**Subject: Transmittal of Class 1 Permit Modification Notification to Update Figures in the Los Alamos National Laboratory (LANL) Hazardous Waste Facility Permit, EPA ID No. NM0890010515**

Enclosure: 1) Class 1 Permit Modification Notification Structure Changes at Technical Area 54

## **Permit Modification Notification**

**Figure 29: TA-54, Area G, Pad 1**

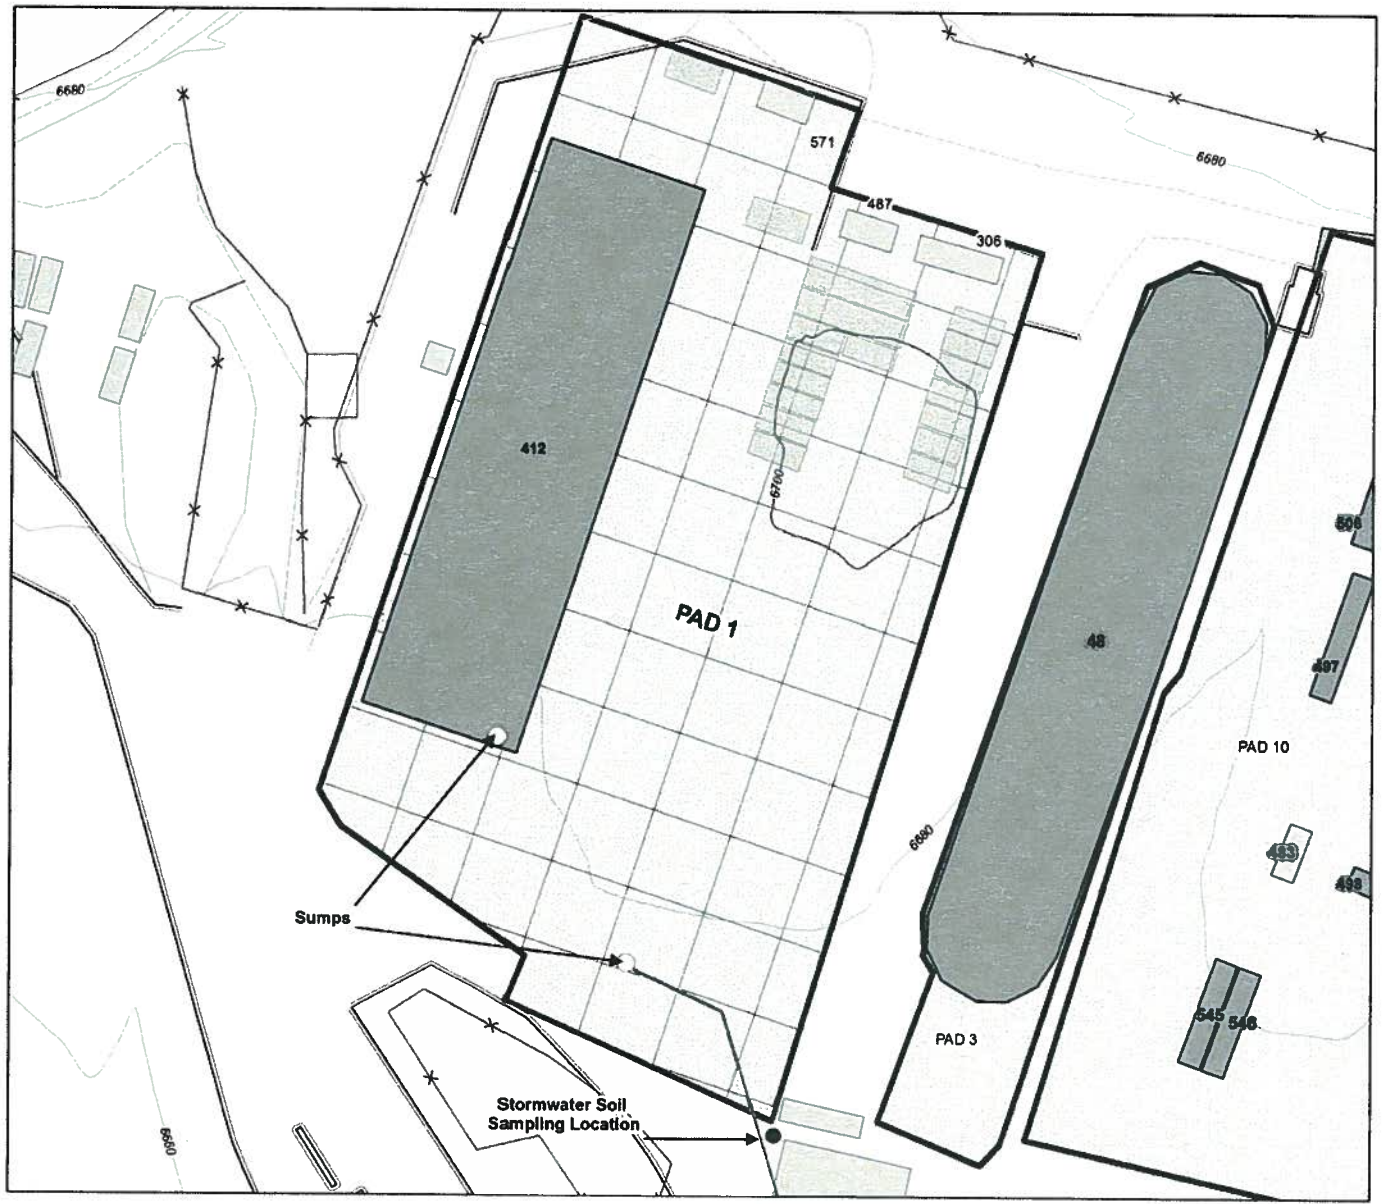
Figure 29 (TA-54, Area G, Pad 1) of Attachment N and Figure G.6-1 (Technical Area 54, Area G, Pad 1 Outdoor Container Storage Unit Grid Sampling Locations) of Attachment G.6 were revised to show the placement of seventeen storage structures at Area G, Pad 1. These structures, which are not “new” structures to Area G but are newly arranged at Pad 1, are not associated with hazardous waste storage activities; therefore, existing structure numbers have been removed.

**Figure G.6-2: Technical Area 54, Area G, Pad 1 Outdoor Container Storage Unit Drainage Sampling**

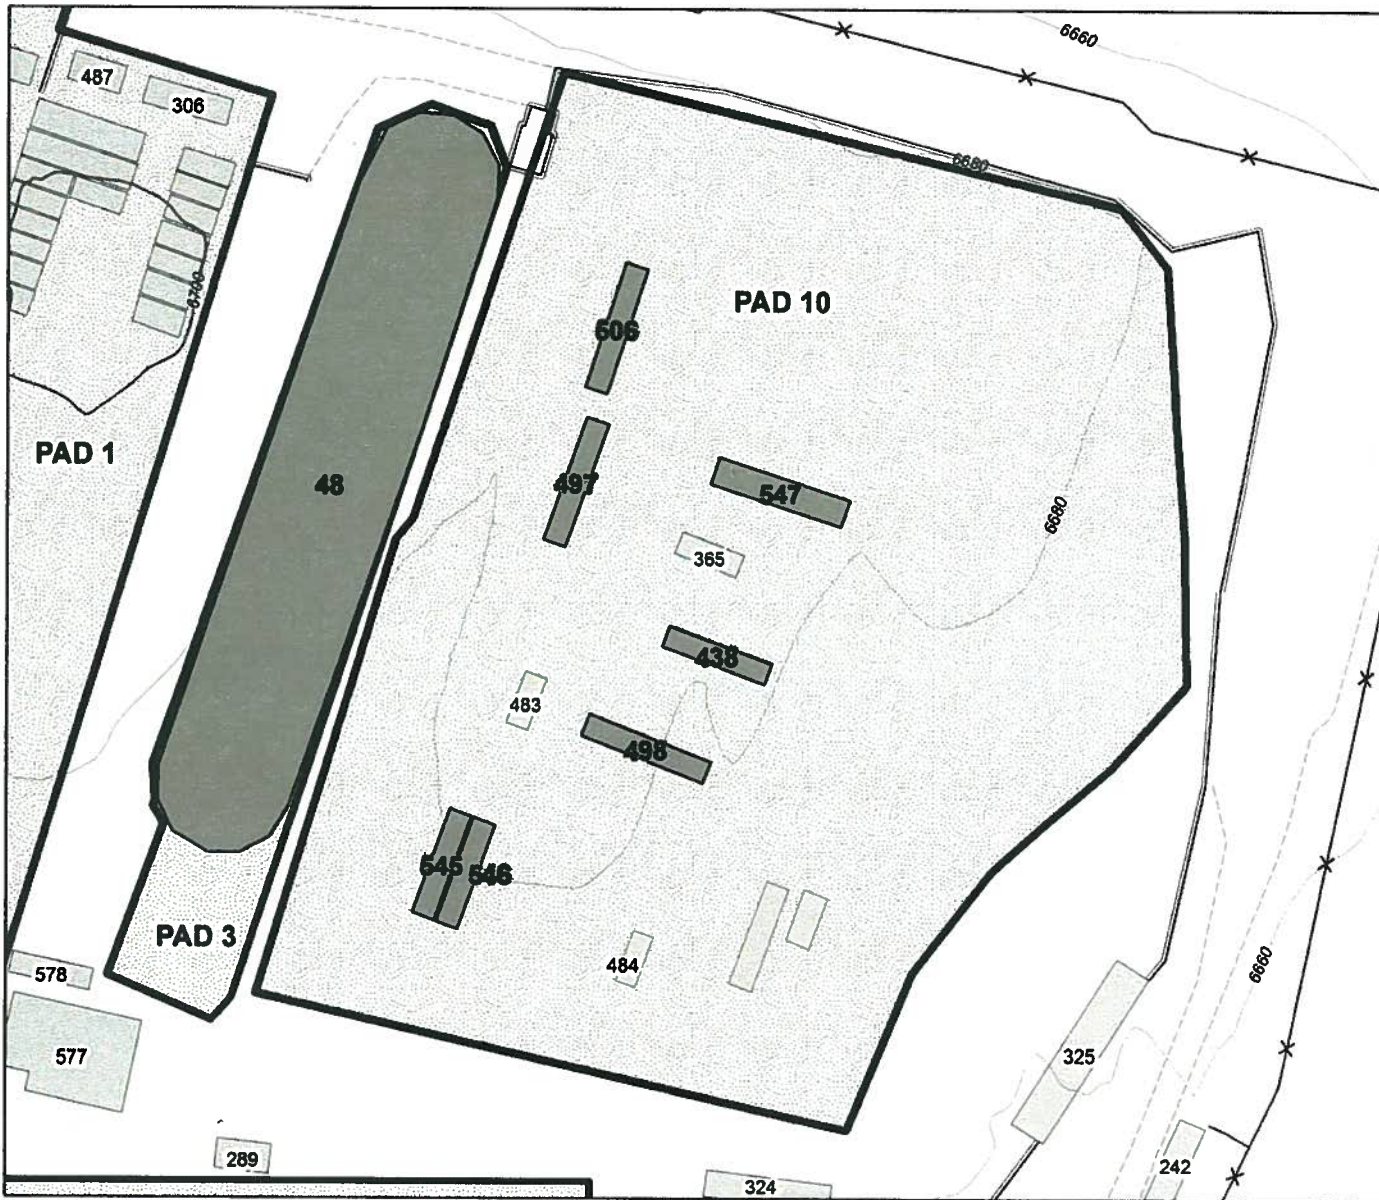
Figure G.6-2 (Technical Area 54, Area G, Pad 1 Outdoor Container Storage Unit Drainage Sampling) of Attachment G.6 was revised to reflect the placement of the seventeen storage structures on Pad 1 (discussed above). To remain consistent with other figure updates, additional changes were made to this figure to show the boundaries and associated structures for Pad 3, Pad

10, and Pad 9. The structures associated with the figure change are not associated with the permitted unit, and they are not used to manage hazardous waste.

**Figure G.11-1: Technical Area 54, Area G, Pad 10 Outdoor Container Storage Unit Sampling Grid and Additional Sampling Locations**

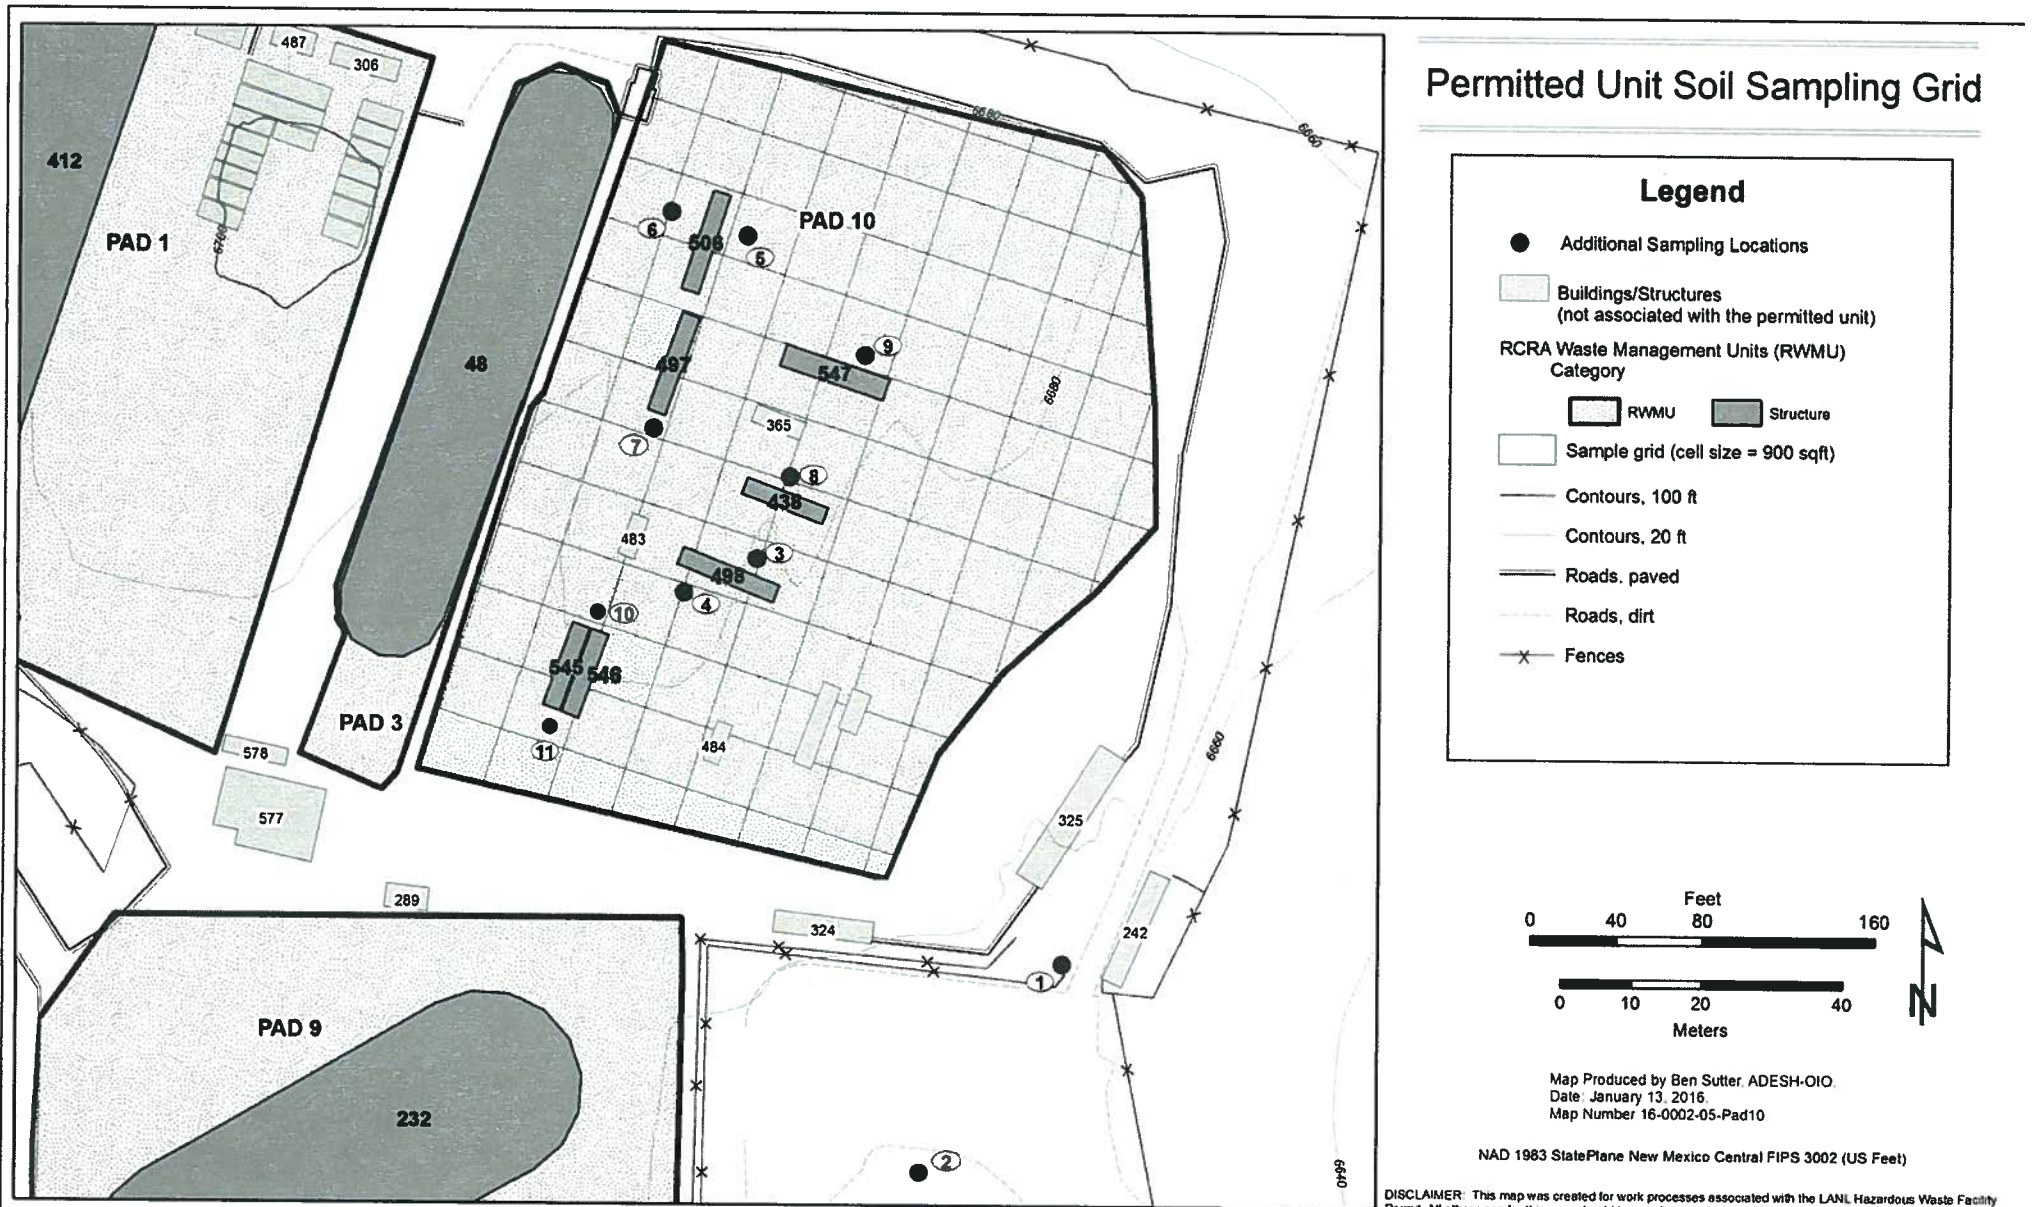
Figure 31 (Technical Area (TA)-54, Area G, Pad 10) of Attachment N and Figure G.11-1 (Technical Area 54, Area G, Pad 10 Outdoor Container Storage Unit Sampling Grid and Additional Sampling Locations) of Attachment G.11 were revised to remove storage trailer TA54-1059, which was relocated to Pad 1 to serve as a storage structure. Other revisions to Figure 31 and Figure G.11-1 include the addition of three support structures (TA54-484 and two additional storage trailers), which were moved to the Pad to serve as storage for equipment and supplies. These structures, which are currently located on the south east corner of Pad 10, are not associated with the permitted unit and are not used to manage hazardous waste. Other changes to the figures were incorporated for the units surrounding TA-54, Area G, Pad 10 container storage unit as appropriate and described within this permit modification.

**Figure 28: Technical Area (TA)-54, Area G, Pad 9 (TWISP Domes 229, 230, 231 & 232)**

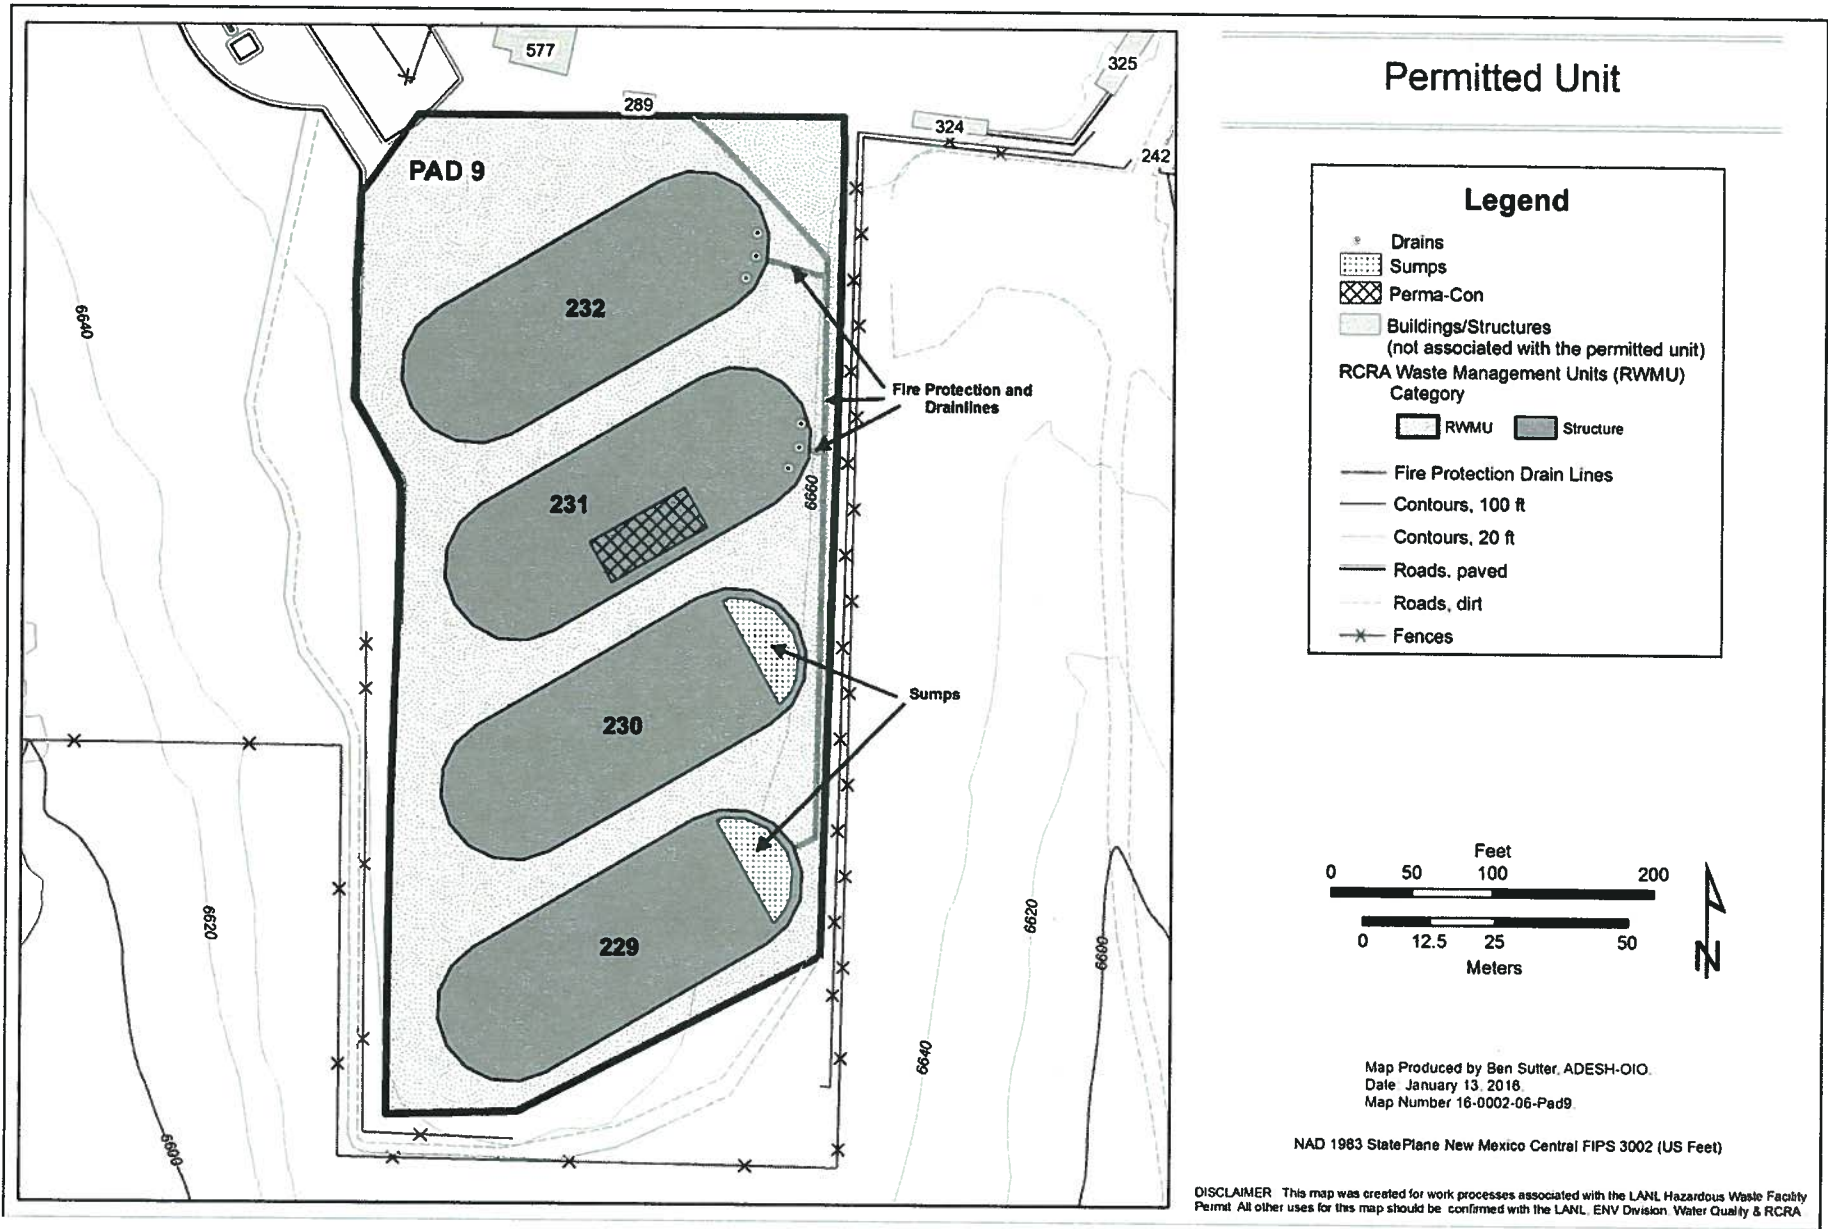
Figure 28 (Technical Area (TA)-54 Area G, Pad 9, (TWISP Domes 229, 230, 231 & 232)) of Attachment N and Figure G.10-1 (Technical Area 54, Area G, Pad 9 Outdoor Container Storage Unit) of Attachment G.10 were revised to remove storage shed 574. This structure, which was relocated to Pad 1 to serve as a storage structure, is not associated with Permit activities or the management of hazardous waste. An additional change was made to Figure G.10-1 to correct typographical errors in the figure's title. The title has been revised from “Figure G.10-1: Technical Area G, Pad 9 Outdoor Container Storage Unit Grid Sampling and Additional

**Figure G.10-1: Technical Area 54, Area G, Pad 9 Outdoor Container Storage Unit Grid Sampling and Additional Sampling Locations**

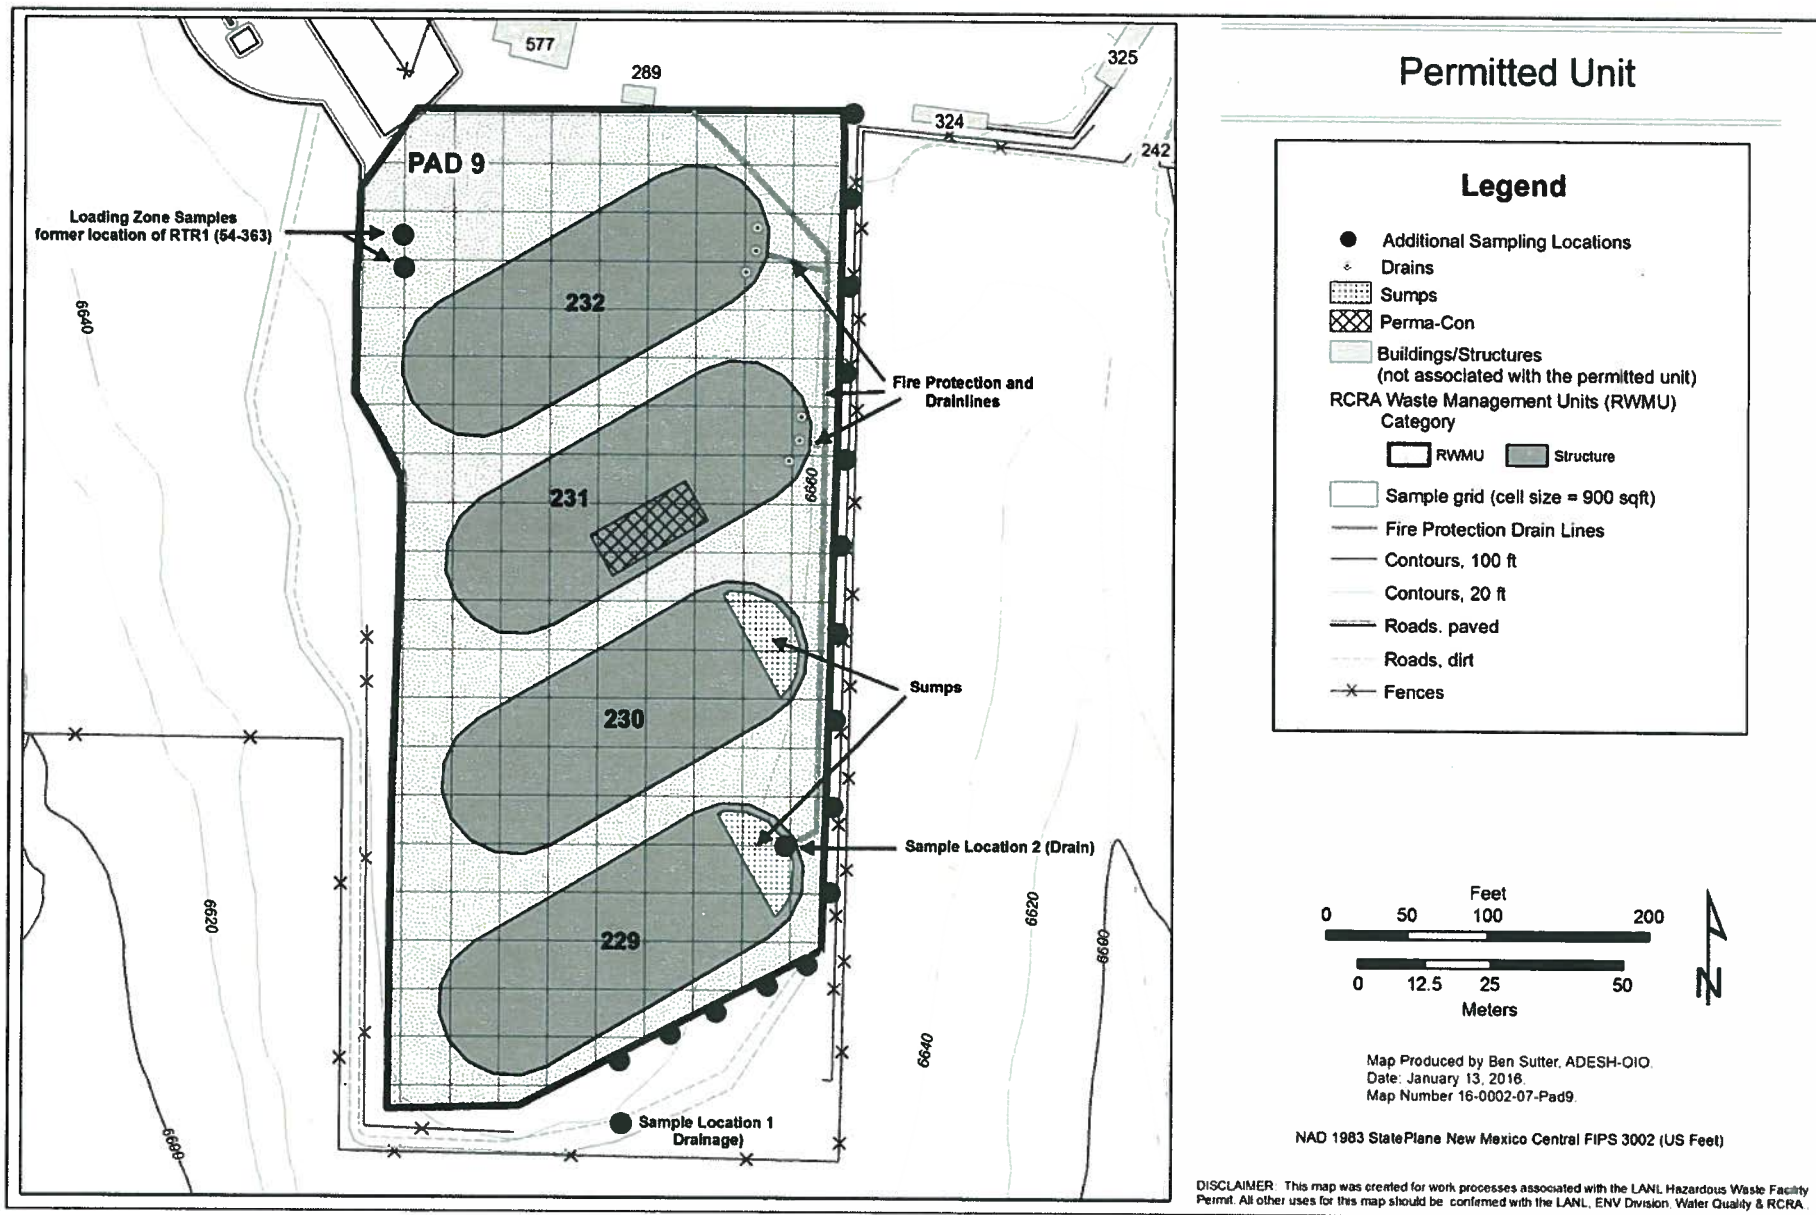
Sampling Locations” to “Figure G.10-1: Technical Area 54, Area G, Pad 9 Outdoor Container Storage Unit Grid Sampling and Additional Sampling Locations.”
